May 15, 2006

**Re: Floodplain GE-Pittsfield/Housatonic River Site  
Floodplain Residential and Non-Residential Properties Adjacent to 1½ Mile Reach of  
Housatonic River (GECD710 and GECD720)  
Addendum to Supplemental Information Package for the Phase 4 Floodplain Properties**

#### REVISED SITE RESTORATION PLAN

REMEDIATION PLANTING PLAN for GROUP 4B FLOODPLAIN PROPERTIES prepared for GENERAL ELECTRIC PITTSFIELD, MA

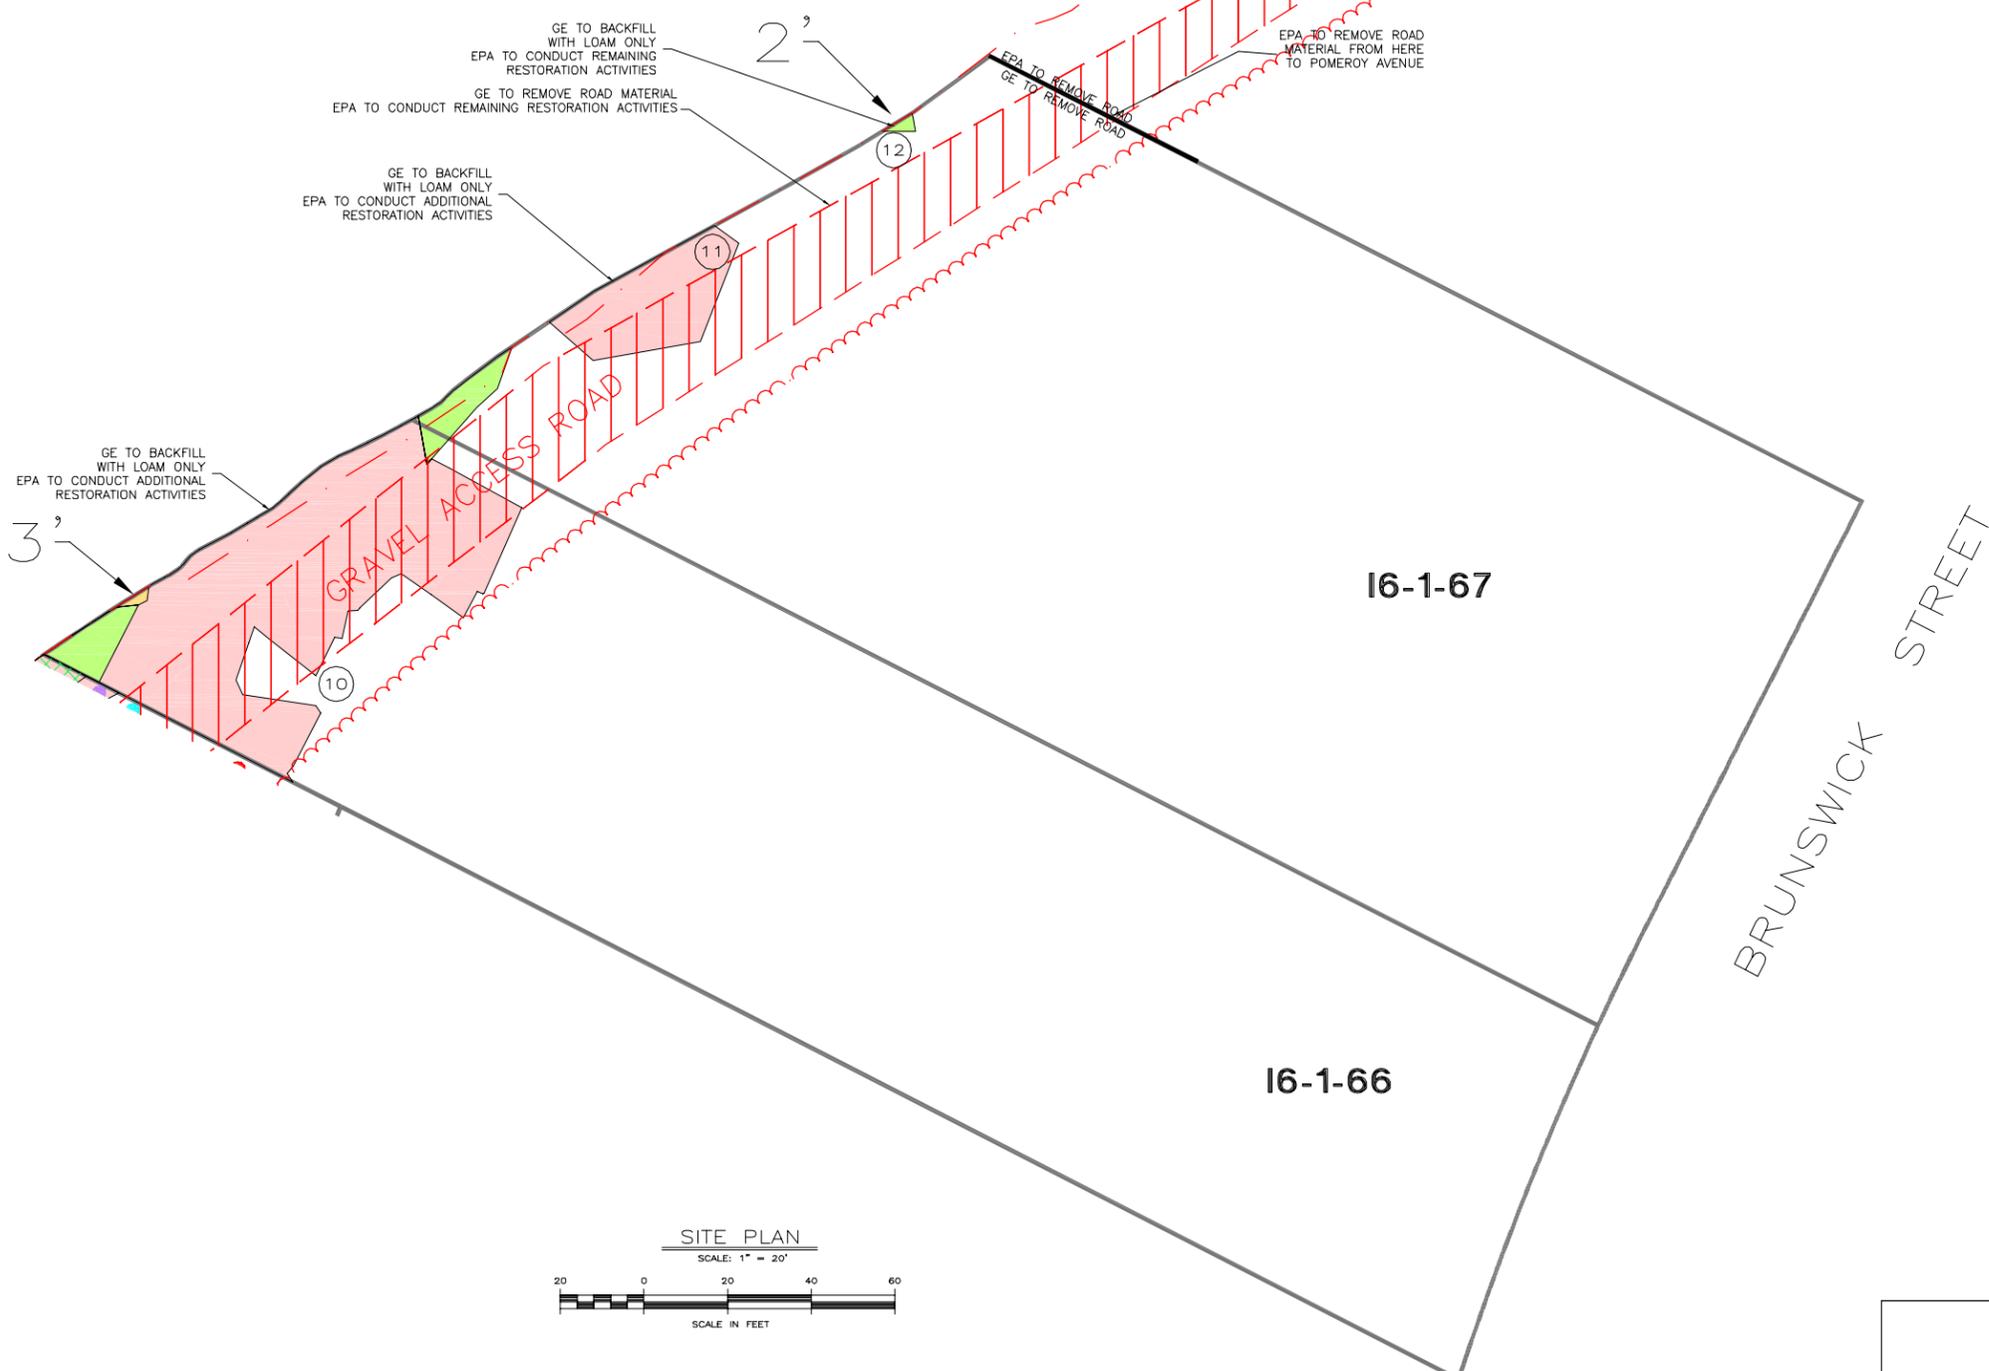
GE TO PLANT 10' WIDE AREA WITH EPA-Suggested Plantings on 10-Foot Strip on Top-of-Bank Along Housatonic River (SEE PLANTING PLAN FOR DETAILS)

GE TO PLANT 10' WIDE AREA WITH EPA-Suggested Plantings on 10-Foot Strip on Top-of-Bank Along Housatonic River (SEE PLANTING PLAN FOR DETAILS)

GE TO REMOVE ALL ROAD MATERIAL

GE TO PLANT 10' WIDE AREA WITH EPA-Suggested Plantings on 10-Foot Strip on Top-of-Bank Along Housatonic River (SEE PLANTING PLAN FOR DETAILS)

GE TO PLANT 10' WIDE AREA WITH EPA-Suggested Plantings on 10-Foot Strip on Top-of-Bank Along Housatonic River (SEE PLANTING PLAN FOR DETAILS)

RED OSIER DOGWOODS TO BE PLANTED IN THIS AREA CONSISTENT WITH UPSTREAM 10-FOOT WIDE STRIP
